MASTER DEVELOPMENT PLAN (MDP) NO: 868

<p>SONOMA SUBDIVISION MASTER DEVELOPMENT PLAN MDP #868</p>	DESIGNED BY: HJ
	DRAWN BY: HJ
<p>PREPARED BY: BAIN MEDINA BAIN, INC. ENGINEERS & SURVEYORS 7073 San Pedro San Antonio, Texas 78216 210/494-7223</p>	APPROVED BY: CB
	DATE: 06-2005
JOB NO.: C-0967	
SHEET 1 OF 1

Re: Sonoma Subdivision

MDP # 868

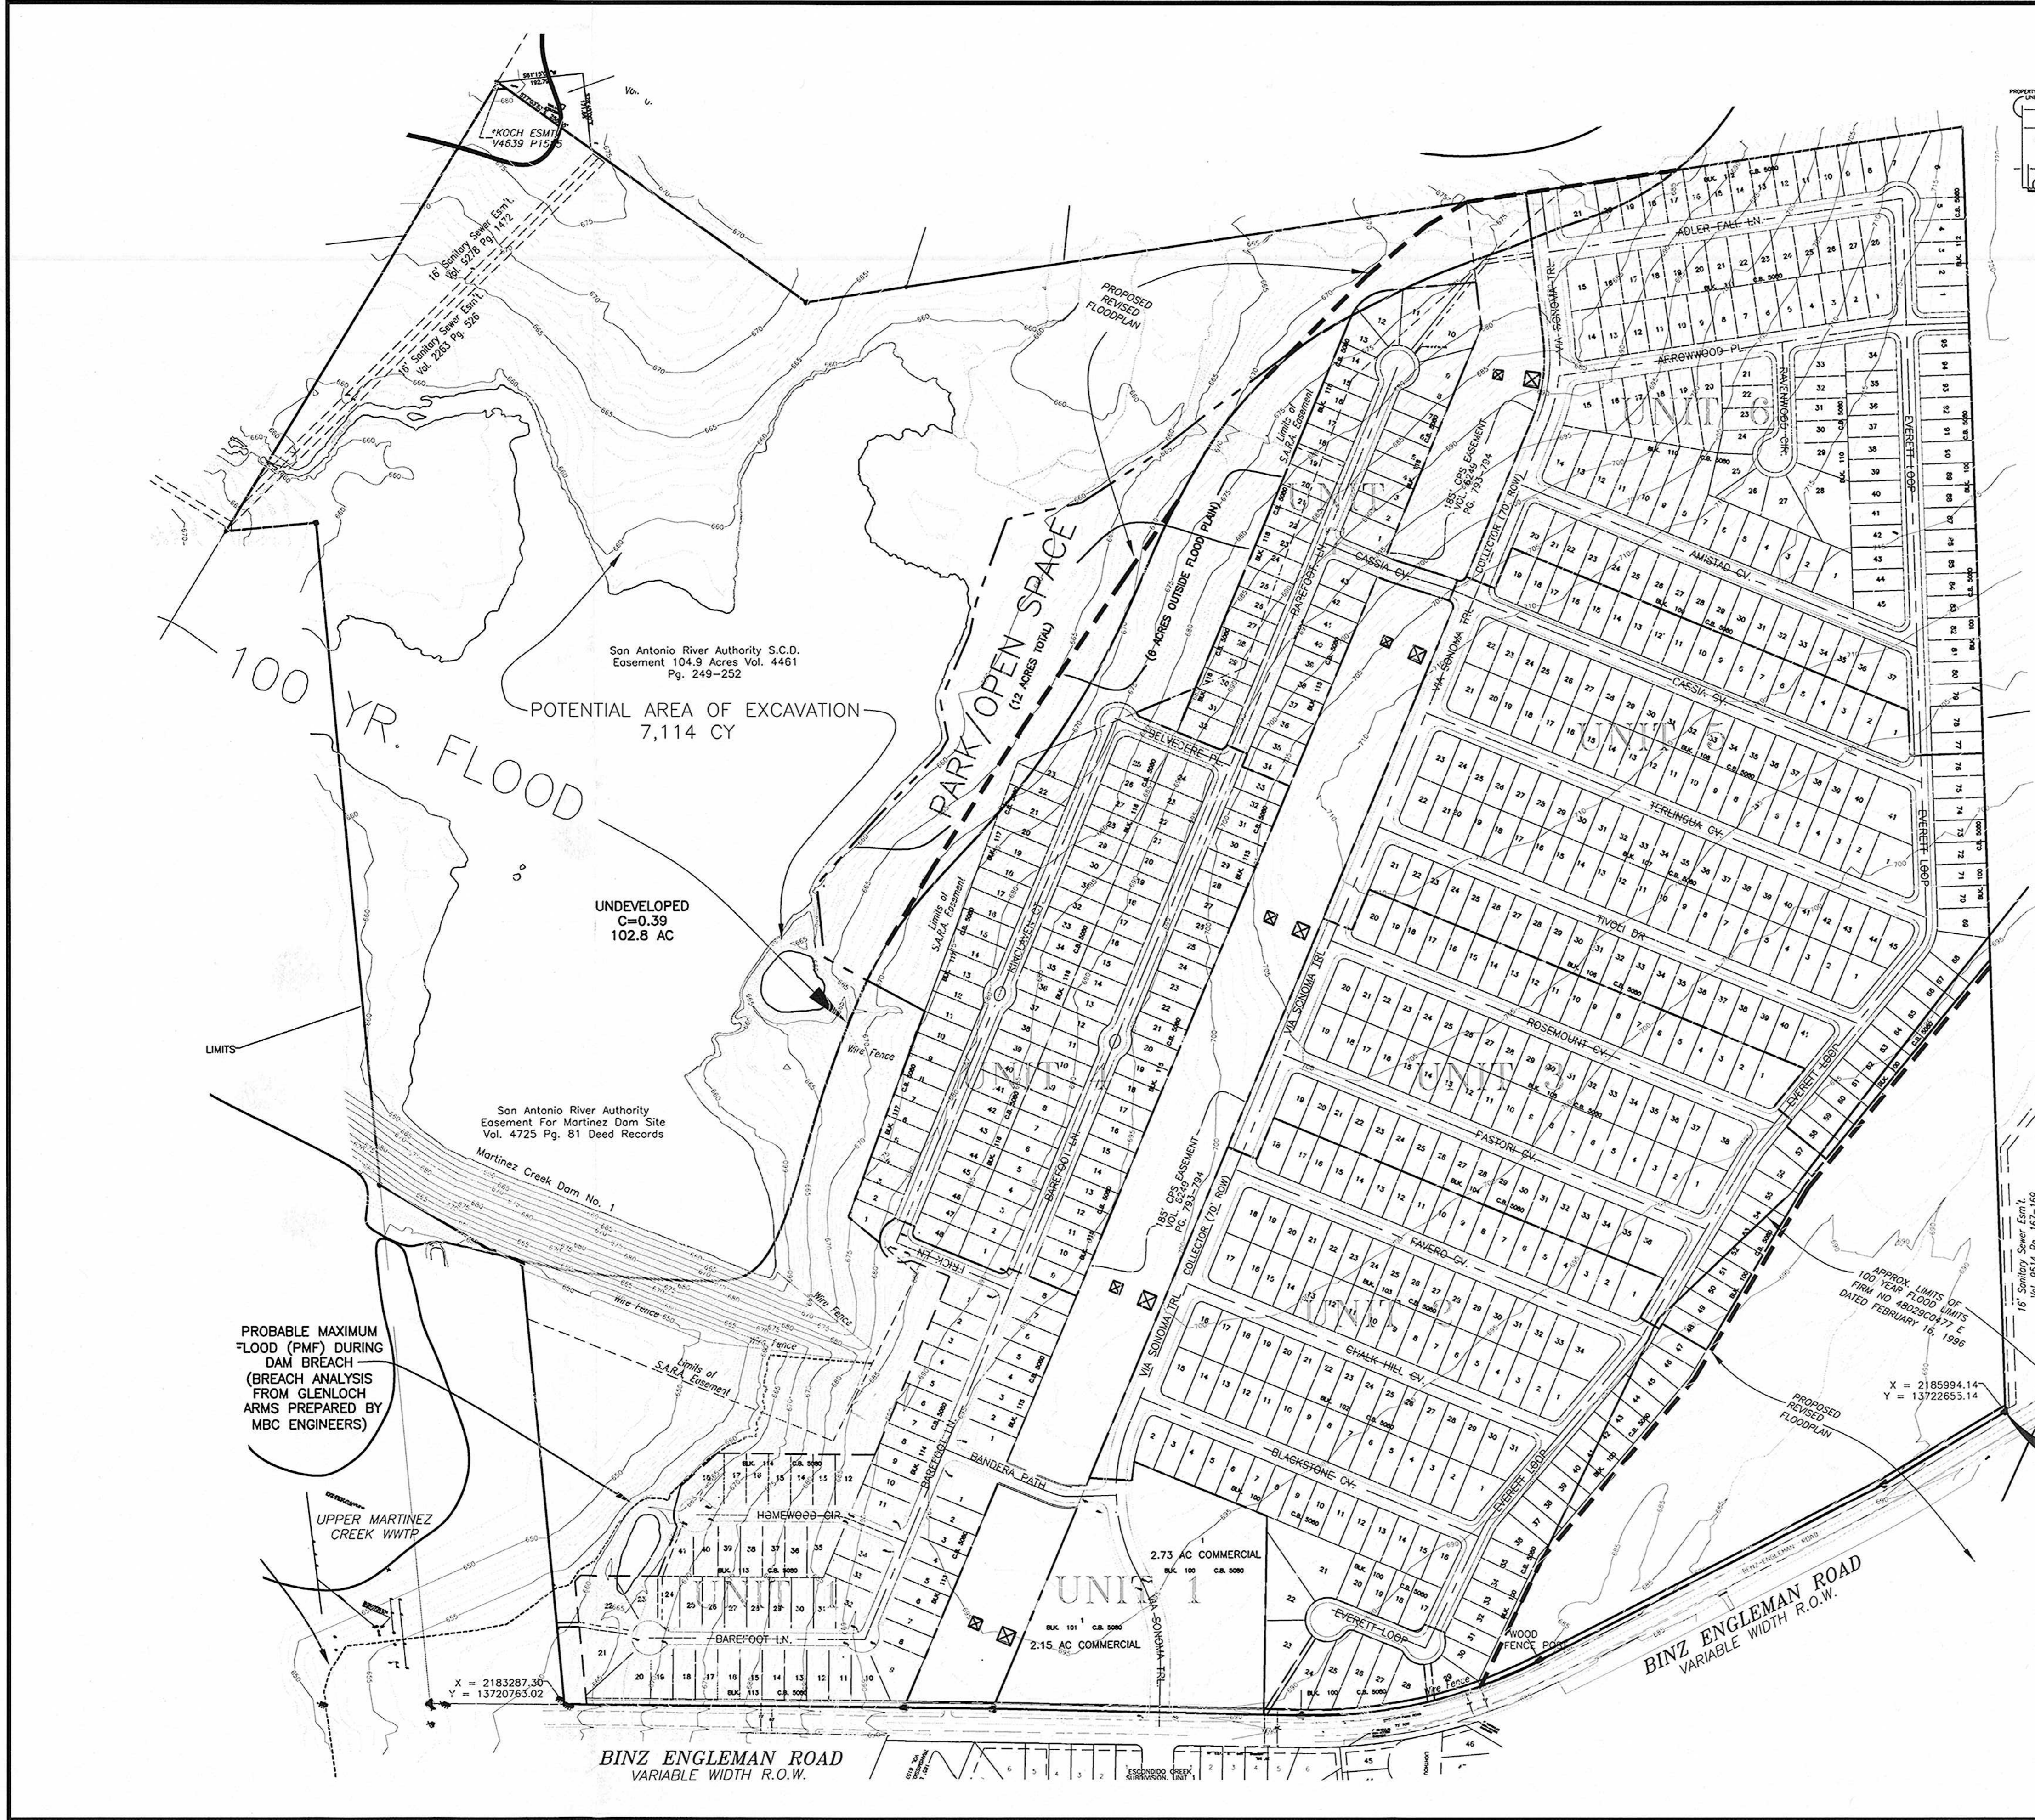
- In consideration of public safety and convenience, excessive grades by reason of topography should be avoided in street layouts and arrangements.
- Any access and R.O.W. issues along state facilities will need to be resolved with the **Texas Department of Transportation (TXDOT)**. For information about these requirements you can contact TXDOT at 615-5814.

- The developer shall be responsible for providing a right-turn deceleration lane (295' with taper) as well as left turn lanes (200' storage and 100' taper) for Binz-Engleman at Via Sonoma Trail (entrance), as it relates to the submitted TIA traffic counts (Uniform Development Code(UDC) - 35-502 (a)(7), subsection C.
- The construction of Unit-4 prior to construction of Unit-7 and the secondary entrance across the CPS easement will overburden Barefoot Lane with over 1,000 vpd. Unit-7 shall be submitted prior to, or in conjunction with Unit-4.

- Access onto Binz Engleman requires an eastbound left turn and a westbound right turn deceleration lane.
- Secondary access to the proposed collector roadway will be required prior to approval of any phase exceeding 125 lots.

It is understood that this MDP is a conceptual plan and controlled access should be maintained in order to uphold safe and efficient traffic flow. Therefore, the developer of this property is encouraged to design common access and shared driveways between all proposed commercial lots. Bexar County reserves the right to address driveways, street design, sight distance, ADA requirements, drainage and floodplain issues at time of platting.

- This project will be subject to the Streetscape standards and 2003 Tree Preservation ordinance. For information about these requirements you can contact **Tree Preservation** at 207-0278.
- I would encourage you to work closely with the school district, so that they can plan accordingly.
- It will be expected that you will plat all of the property depicted in your Master Development Plan (M.D.P.), to include floodplains, drainage areas and open space.
